PR/0002/23

Record of Executive Business and Chief Executive's Order

Reg. Reference:SD22A/0330Application Date:11-Aug-2022Submission Type:AdditionalRegistration Date:30-Nov-2022

Proposed Development: Construction of a single storey valeting building and

Figure 1 Extract from Proposed Site Layout Sheet 2 of 5 from Reg. Ref. SD21A/0291.

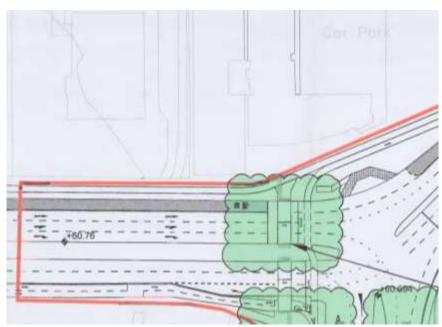
The permitted upgrades to Fonthill Road, under Reg. Ref. SD19A/0320, and amendment application Reg. Ref. SD21A/0291, show that the existing access from Fonthill Road to the site would be removed. The footpath would be extended across the southern boundary of the subject site, a cycle path and bus lane would also extend along Fonthill Road.

However, based on a site visit on the 14th of September 2022 it appears that a vehicular access from Fonthill Road to the subject site is being reinstated as part of these upgrade works.

The submitted site plan with the subject application also shows this southern access. Although the application documentation states that the northern access would be the site's entrance and exit. It is not clear from the application material if any changes are proposed to the southern boundary/access, which currently has a vehicle barrier gate and green palisade fencing across it.

From a further phone conversation with the Roads Department, on the 29th of September 2022, they expressed concern with reopening the southern access given that this was not provided for under the adjoining application for Fonthill Road and would cross a cycle path and a bus lane.

However, the applicant should be requested to provide additional information in relation to the historical use of the site as an access road, if known, and importantly, what is proposed in relation to the southern boundary/access. The applicant should take into account that the Fonthill Road upgrades do not permit an access to the subject site. **This should be addressed via additional information.**

- 1. The southern entrance onto Fonthill Road must remain closed to vehicles.
- 2. Any gates shall open inwards and not out over the public domain.
